Dresden Nuclear Power Station, Units 2 and 3  
Renewed Facility Operating License Nos. DPR-19 and DPR-25  
NRC Docket Nos. 50-237 and 50-249

Subject: Supplement to the Dresden Nuclear Power Station Fifth Inservice Inspection Interval Relief Request I5R-01

**ATTACHMENT**  
**10 CFR 50.55a Request Number I5R-01, Revision 1**  
**Proposed Alternative In Accordance with 10 CFR 50.55a(a)(3)(ii)**  
**--Hardship or Unusual Difficulty without Compensating**  
**Increase in Level of Quality and Safety--**

**FIGURE I5R-01.1: Two (2) Inch Standby Liquid Control Nozzle**

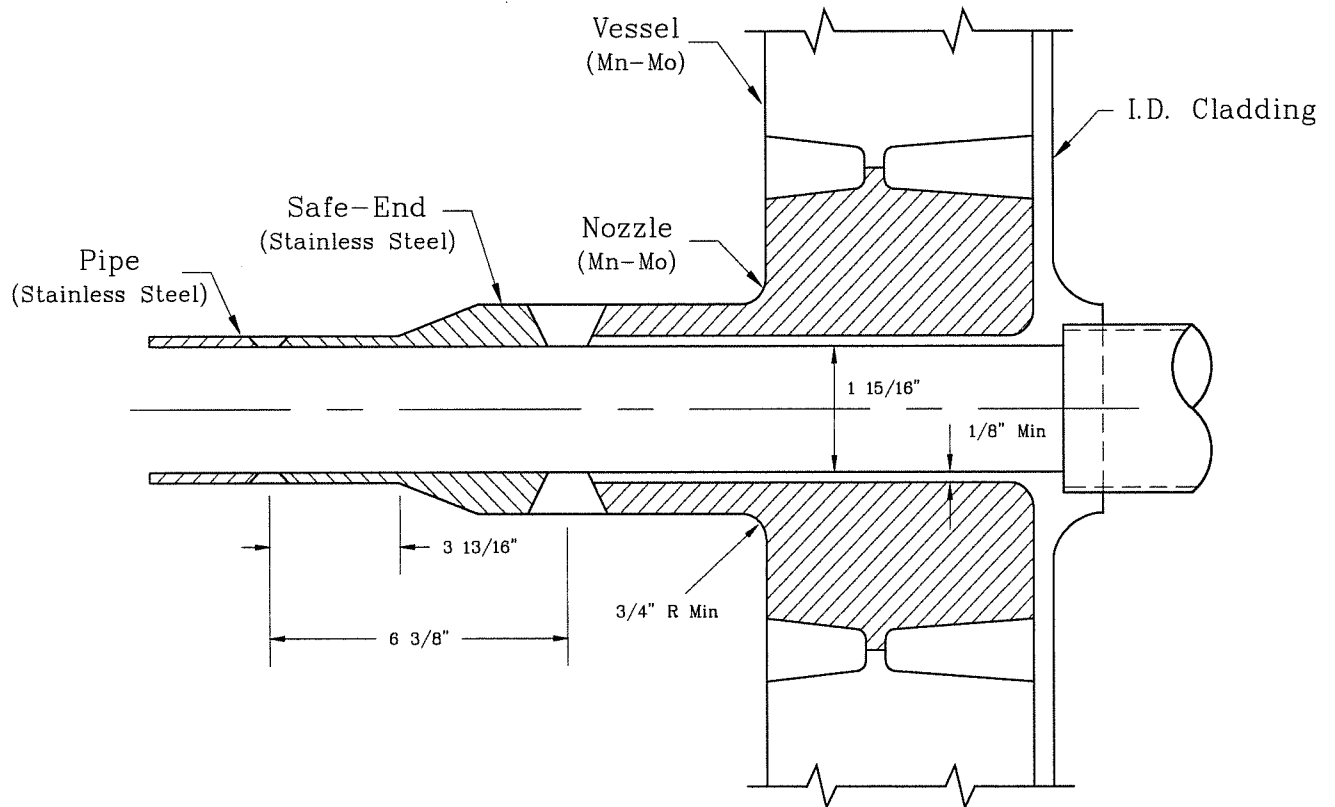
The Standby Liquid Control (SBLC) nozzle, as shown in Figure I5R-01.1, is designed with an integral socket to which the boron injection piping is fillet welded. The SBLC nozzle is located near the bottom of the vessel in an area which is inaccessible for ultrasonic examinations from the inside of the vessel. Therefore, ultrasonic examinations would need to be performed from the outside diameter of the vessel. As shown in Figure I5R-01.1, the ultrasonic scan would need to travel through the full thickness of the vessel into a complex cladding/socket configuration. These geometric and material reflectors inherent in the design prevent a meaningful examination from being performed on the inner radius of the SBLC nozzle.

Compliance with the applicable Code requirements would require an ultrasonic examination to be performed on the outside diameter of the reactor pressure vessel. Geometric and material reflectors would prevent a meaningful examination, resulting in inaccurate data. Based on this, the Code requirements impose hardship without a compensating increase in the level of quality and safety in accordance with 10 CFR 50.55a(a)(3)(ii).

As an alternate examination, Exelon Generation Company, LLC will perform a VT-2 visual examination of the subject nozzles at DNPS, Units 2 and 3 each refueling outage in conjunction with the Class 1 System Leakage Test.
